STATE OF WASHINGTON
DEPARTMENT OF ECOLOGY

Re: Further Action at the following Site:

- **Site Name:** Main Street Grocery
- **Site Address:** 901 Martin Luther King Jr. Way, Tacoma, WA
- **Facility/Site No.:** 53355321
- **Cleanup No.:** 12291
- **VCP Project No.:** SW1481

Issue Presented and Opinion

Figure 1

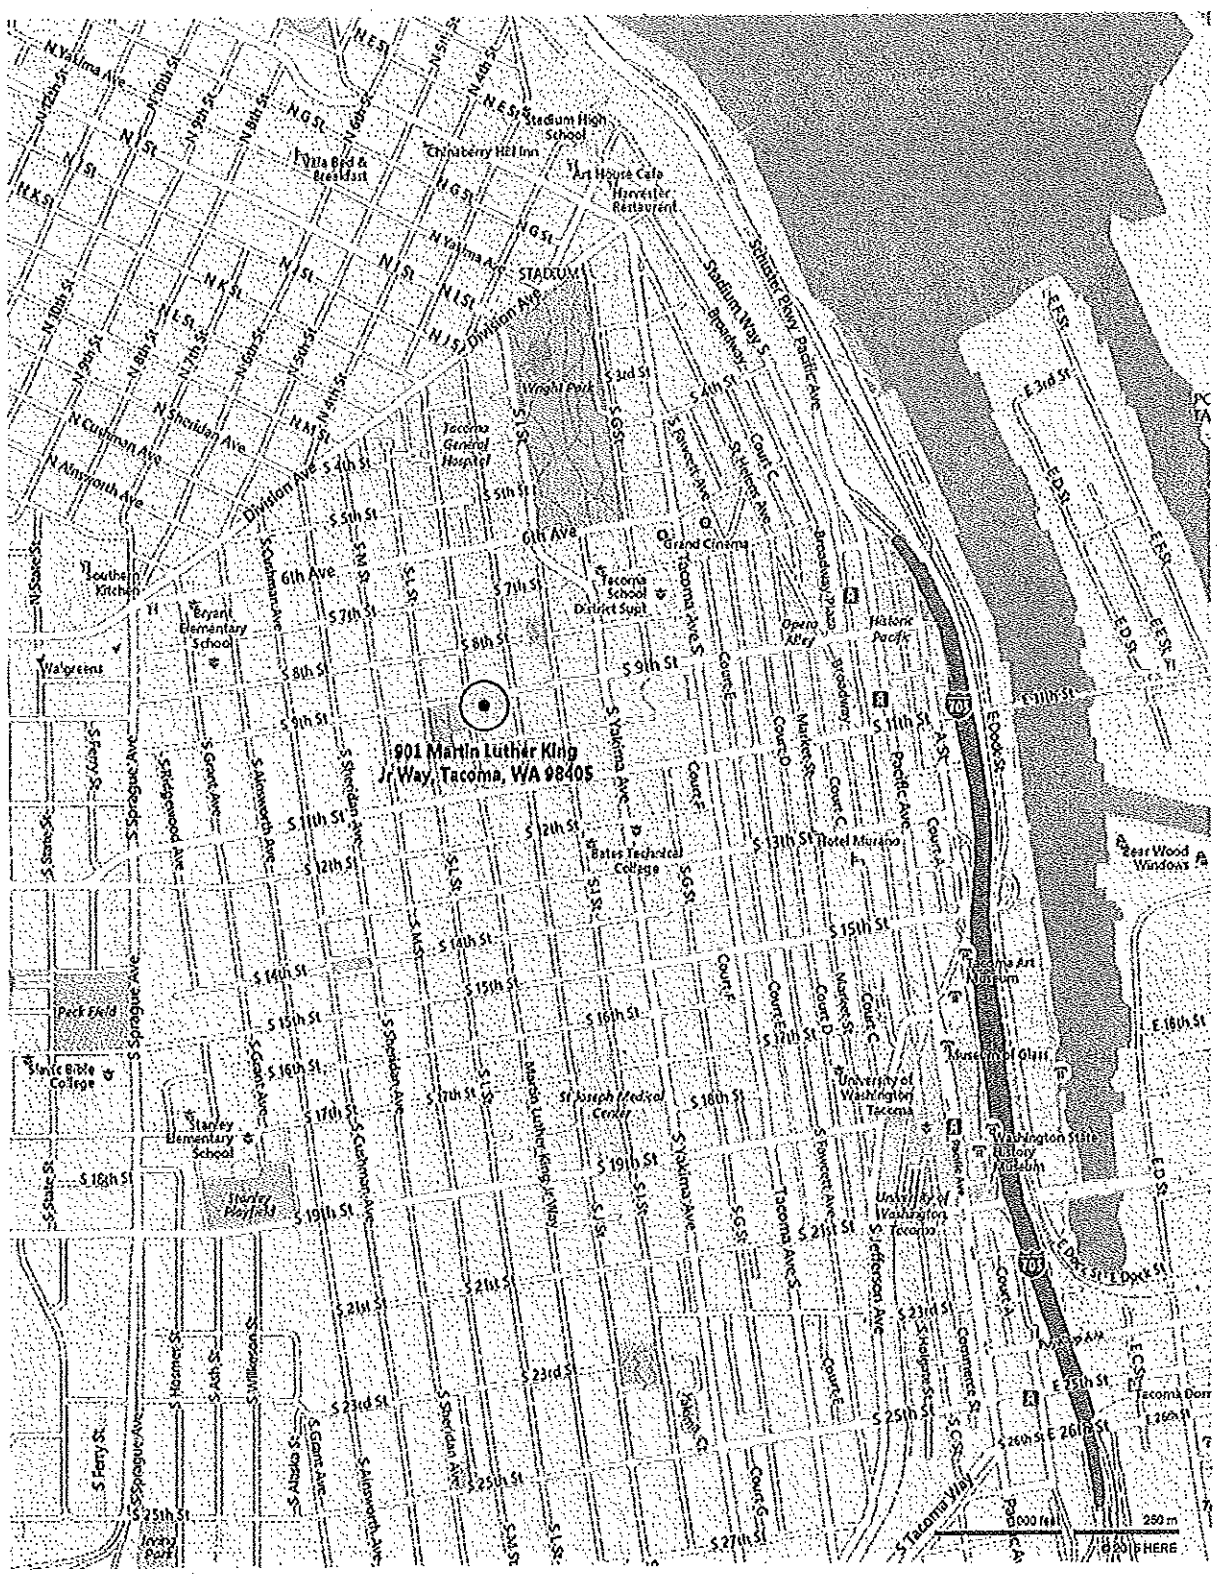
The Site is located on the southeast corner of the intersection of Martin Luther King Jr. Way and South 9th Street in Tacoma, Pierce County, Washington (Figure 1). It is comprised of two tax parcels with a combined area of 0.3 acres. The business building, with the address of 911 Martin Luther King Jr. Way, is located on a third parcel to the south and is 0.15 acres. The building at the Site contains the Main Street Grocery and several other small businesses.

2. No sampling or sample preservation protocols were detailed in the report. Without this information, the sample results are not useable.
3. A figure showing the relationship of features at the Site to surrounding facilities is needed. The one figure in the report has no north arrow or streets shown. A general location figure was also not included.

FIGURE 2

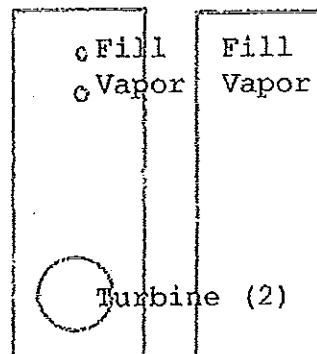
Results of this investigation found a detection of benzene at 14 feet bgs in sample 2AE (figure 2). The concentration was 0.038 milligrams per kilogram (mg/kg). The Method A cleanup level for benzene is 0.03 mg/kg. Total Petroleum Hydrocarbons-Gasoline (TPH-G), toluene, ethylbenzene, and xylenes were found in the sample but were below their Method A cleanup levels.

4. The report states that HCID found TPH-O present at sampling location 3N-5 yet no quantitative analysis was done. BTEX should also have been analyzed. These analytical results are needed for characterization of this area.

6. The Site figure does not show the location of the closed-in-place UST. Since no information was found on the decommissioning of this tank, samples need to be collected to verify that it did not leak.

7. The detection of benzene above the Method A cleanup level was collected in boring 2AE at 14 feet bgs. Samples were not collected either above or below the 14 foot sample so vertical extent is not known.
